**Project #21-035
Homestead Changes
Located at approximately 607 West 200 North**

Project Name: Homestead Changes
Proponent / Owner: Bracken Atkinson / 200 North Land Holdings LLC
Project Address: 625 West 200 North
Request: Design Review & Subdivision Permit
Current Zoning: Mixed Use (MU)
Type of Action: Quasi-Judicial
Hearing Date: July 8, 2021
Submitted By: Russ Holley, Senior Planner

RECOMMENDATION

Figure 2 shows the proposed new phase 4 site plan (phase 4 is now proposed as phase 4, 5 & 6)

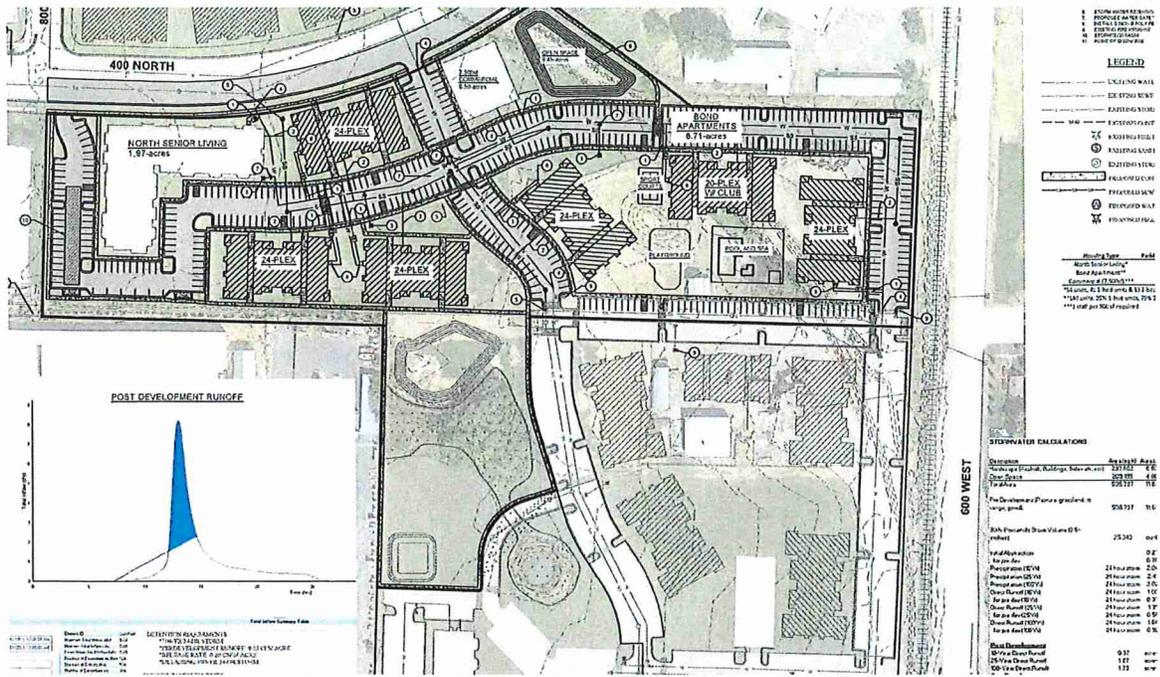
The 11.18-acre phase four area is now proposed to be subdivided into three smaller lots and broken into phases 4, 5, & 6. Phase 4 is the proposed 7,500 SF commercial building located at the northeast corner of the project near 400 North. Phase 5 is the proposed north senior living 55-plex near the northwest corner of the project. Phase 6 is now proposed with 6 multi-family residential buildings (five 24-plex and one 20-plex). The Land Development Code (LDC) allows 30 units per acre in the MU zone. The LDC requires a 60% building frontage and a maximum front setback of 10 feet. Commercial buildings in the MU zone are required to have 12-foot-tall ground floor heights and 60% transparency on street facing facades. The LDC states that multi-family residential projects comply with building design residential standards in the Mixed Residential (MR) code sections.

Density for phase four is proposed at 17.4 units per acre and the proposed building frontage is 58% (is this for all of phase 4??). At ~760 feet wide the parcel would require 456' wide building to achieve 60% frontage. The proposed building(s) total 469 feet in width and a 61% frontage (this is inconsistent with the 58% above – clarify which is correct). The proposed front setbacks for the three buildings along 400 North are at or below the 10-foot maximum setback. The two proposed residential building designs shows the minimum 15% transparency on street facing facades and a mix of materials, colors and articulation as per the Mixed Residential façade design standards. The proposed commercial building shows a building design with 40% transparency and ten-foot first floor heights. As conditioned with compliance with commercial transparency and floor heights, the phase four changes comply with the regulations in the LDC. The Planning Commission can consider utilizing their design discretion authorized in LDC 17.43.080 for those areas that fall within a 10% deviation.

7. All buildings in phases 4, 5, & 6 shall meet the minimum 60% building frontage and a maximum front yard setback of 10 feet.
8. The commercial building in phase 4 shall have a minimum 50% transparency and 12-foot-tall ground floor height.

Figure 3 shows the proposed new exterior façade of the 55-plex)

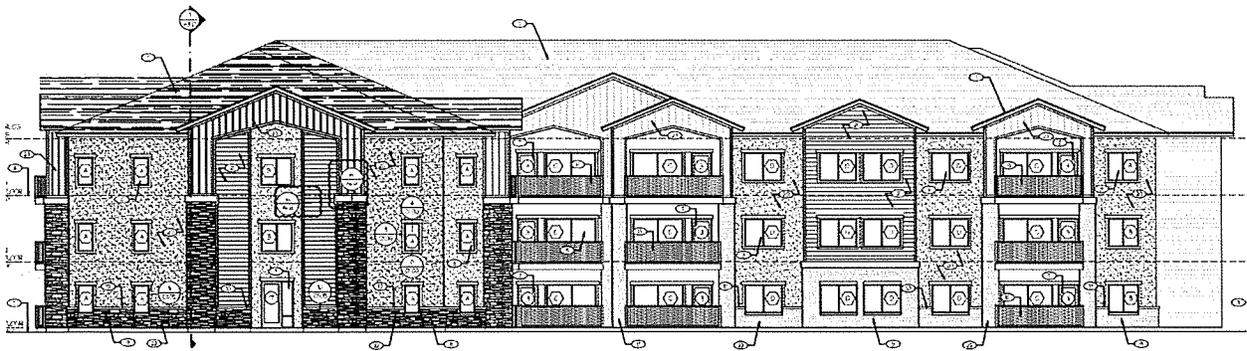
The LDC 17.12 indicates that buildings in the MU zone shall vary from one another, have four-sided architecture and a mix of materials. Acceptable building materials are masonry, stucco, fiber-cement board, wood and metal. Material mixes shall wrap all four sides of buildings and blank walls exceeding 40 linear feet are prohibited. Vertical dimensions of blank wall shall not

exceed 12 feet and roof forms should be varied for visual interest. Buildings shall be oriented to the street with primary entrances facing towards the street. Secondary entrances should face the side or rear. Alternatively, in cases where the primary entrance is not facing the street, the street facing façade shall closely mimic that of the primary entrance façade. Surface parking lots are prohibited between the street and the building (front yard areas) and required to be at the side or rear of the building. Commercial/Mixed Use buildings are required to have 50% transparency (fenestration) along ground-floor street frontages and residential buildings are required to have 15% transparency along street frontages. The proposed changes show differing building types along the street frontages and meet the building variation standards.
